INFO-TECH CITROËN Racing C3R5 20-05

Sujet : Bride d'admission (904475328F)

Subject: Turbo restrictor (904475328F)

Plombage turbo / Turbo seal

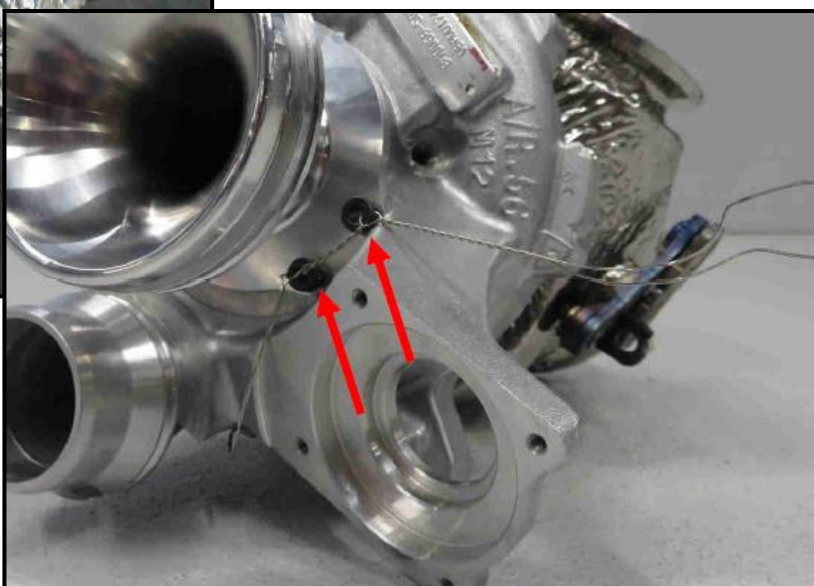
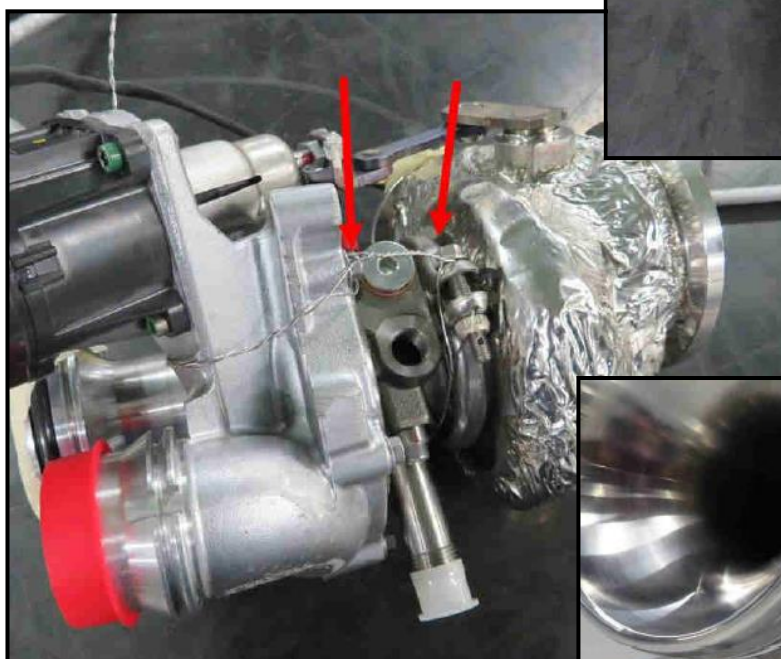
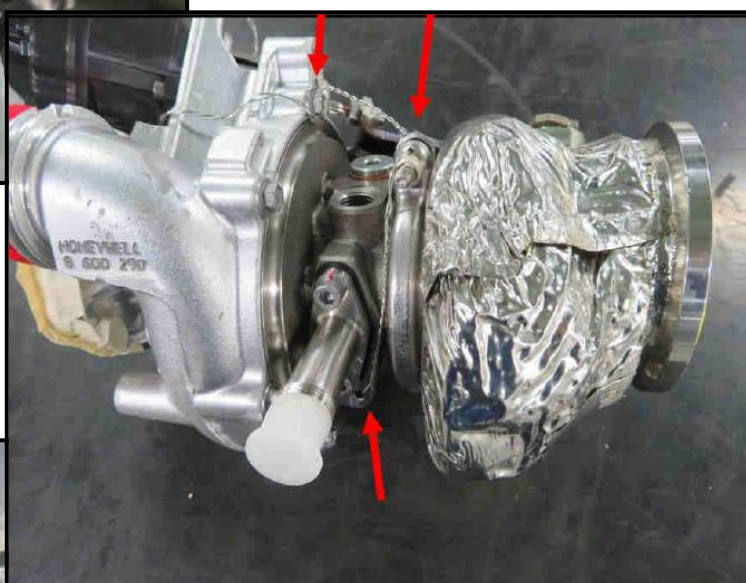
Vous trouverez également en annexe, les photos FIA pour le plombage du turbo.

You will also find on annex, the new FIA pictures for the turbo sealing.
